AERONAUTICAL CHARTING MEETING

RECOMMENDATION DOCUMENT

FAA Control #21-02-363

Subject: Depict ARINC 424-Coded Missed Approach Point on Conventional Charts

Figure 4. Conventional without depicted MAP.

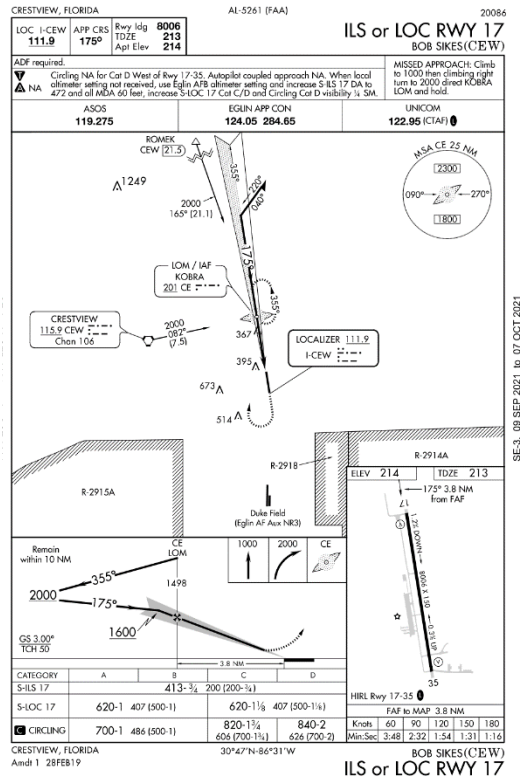
Figure 6 shows the FMS representation of a conventional procedure without a depicted MAP, which diverges from the chart shown in Figure 4 because the FMS adds the ARINC 424-coded MAP of “RW17.”

When the MAP is not charted/depicted the chart contains timing. Operational experience supports timing is an inaccurate way to identify the missed while contributing to a higher pilot workload. With the widespread adoption of RNAV systems (aka, GPS), pilots tend to identify the missed using their FMS.

1. Procedure design include the RNAV fix for the MAP; and
2. Charts depict this MAP.
